METRO EAST END COMMUNITY ADVISORY BOARD HARRISBURG SIDEWALK COMMITTEE

WALKABILITY REPORT

MARCH 2013

3.1 - 3000 North

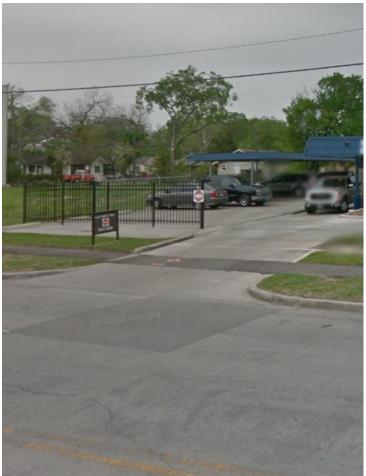
Significant space along here for amenities, trees, bus shelter, & street furniture.

3.3 - 3000 North

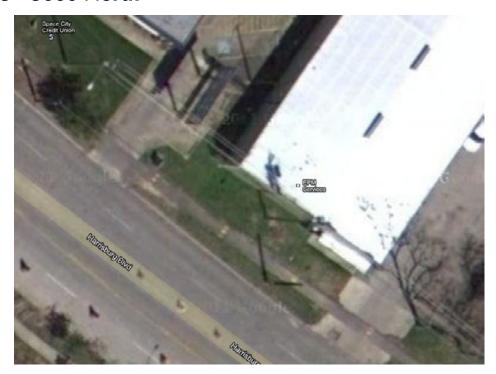
Driveways need striping.

3.4 - 3000 South

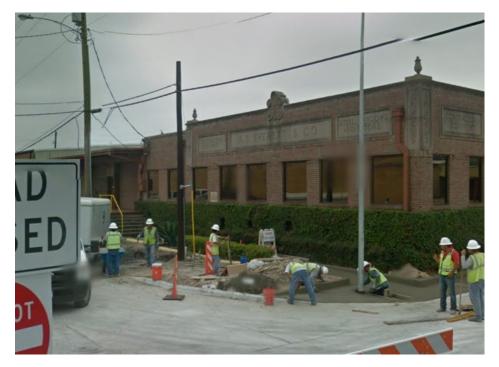
Trees need planting.

2B.2 - 3100 South

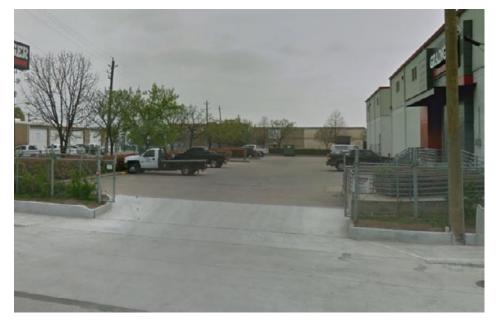
Driveway at GEEMD needs striping.

2B.9 - 3400 South

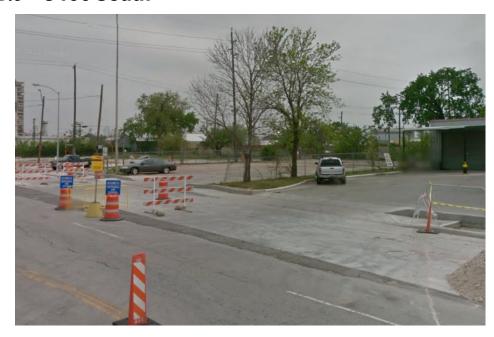
Three driveways need marking.

2A.7 - 4300 South

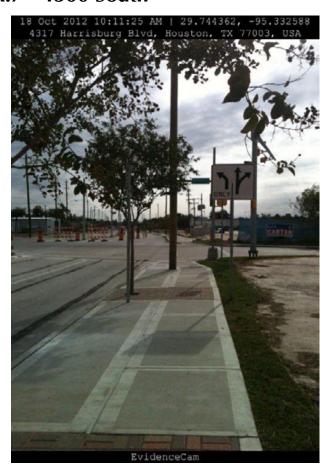
This unnumbered power pole creates a severe walkability issue.

1B.7 - 5000 South

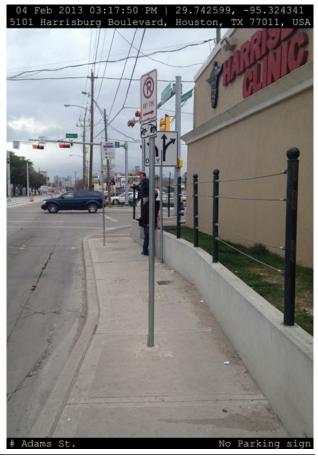
Power Pole 213090 creates a really sever walkability problem as well as being placed in the center of the walkway and in the space reserved and constructed by the Greater East End Management District for the street name.

1B.12 - 5300 North

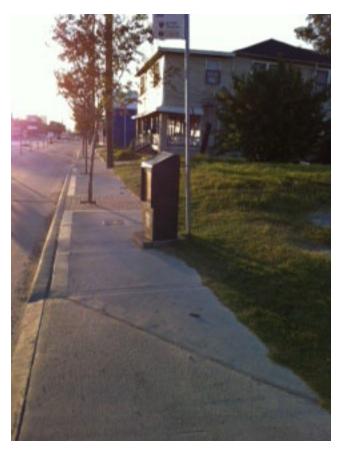
Newspaper dispenser on concrete pad attached with a chain and lock to a METRO bus stop pole impedes walkability.

1.6 - 6600 South

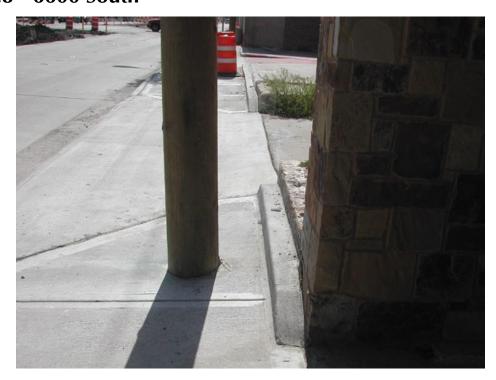
Addresses 6600 and 6624 Harrisburg both have flooding problems, only storm drain on this side is at the corner of Harrisburg and Cesar Chavez.

1.9 - 6700 North

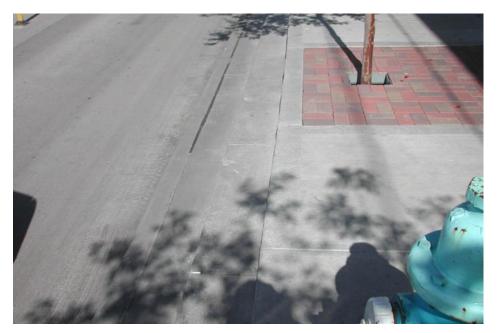
No storm drains along the north side of this block. Business owners, managers, and residents state flooding occurs into businesses and yard of home owner. (Nearest drain is in the middle of the 6600 block.

1.12 - 6700 North

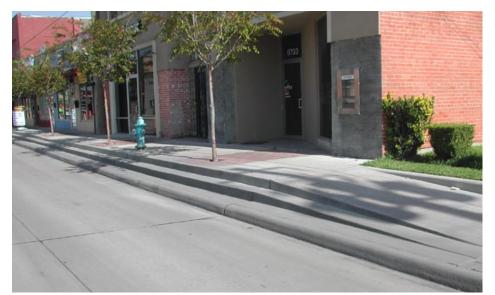
AT&T parking lot has a 96-inch wide sidewalk with a green space of 32 1/2 inches to property line. Potential for landscaping or other amenities.

1.13 - 6700 North

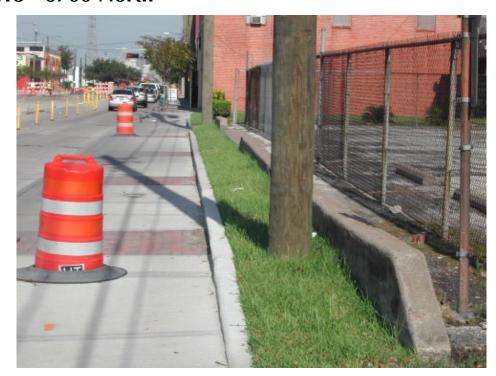
In front of AT&T building, sidewalk is 129"; potential for benches or other amenities.

1.14 - 6700 North

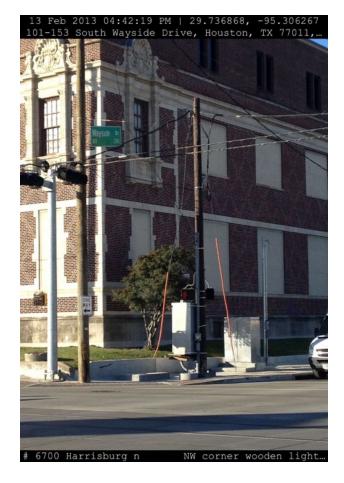
Northwest corner has a wooden traffic light pole, two guide wires, and a signal box—remove and replace?

1.22 - 6800 North

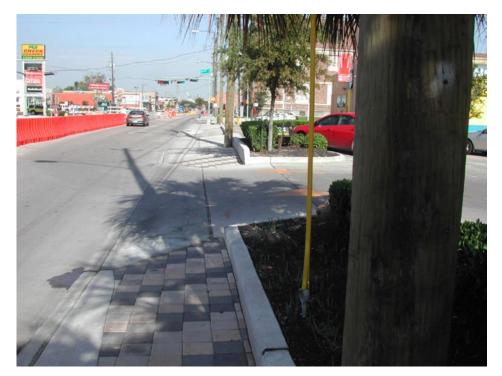
6810 Harrisburg business—driveways are elevated 2 1/2" to 3" from sidewalk creating a tripping hazard.

1.26 - 6800 North

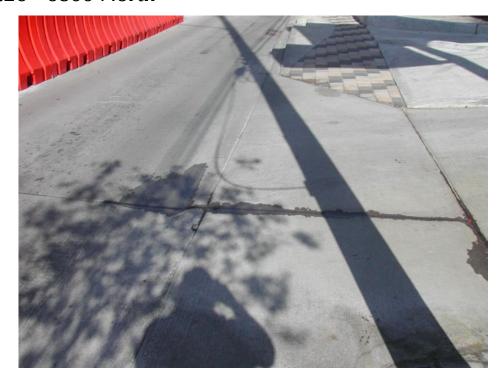
All driveways along this block need markings.

1.32 - 6900 North

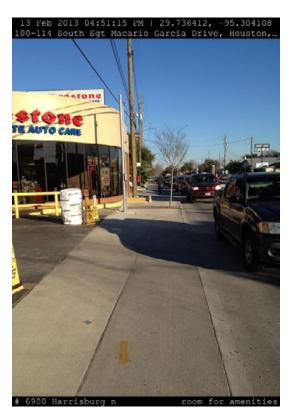
Deep sidewalk, with many opportunities for bike racks and benches—important because of proximity to Magnolia Park Transit Center.

1.33 - 6900 North

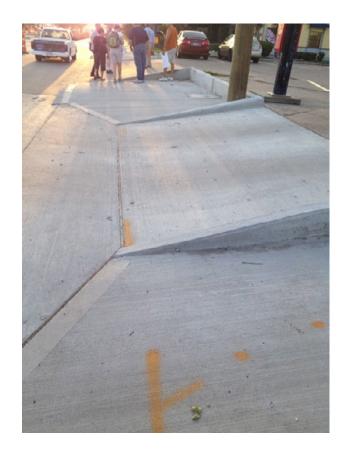
Sidewalk is always directed toward street, due to slope—need to provide direction for pedestrians and provide warning to autos in street. Also, need to provide some "warning" (reflective paint?) on abrupt edges separating driveways into businesses from the sidewalks.

1.34 - 6900 South

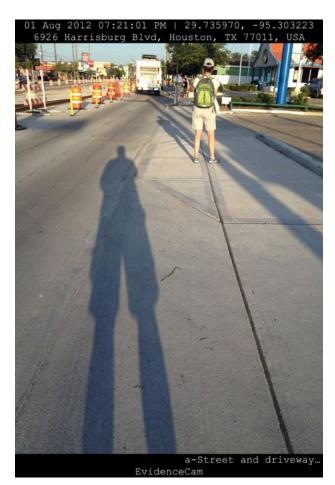
In front of Payday store and Whataburger, provide driveway markings to avoid car/pedestrian interference.
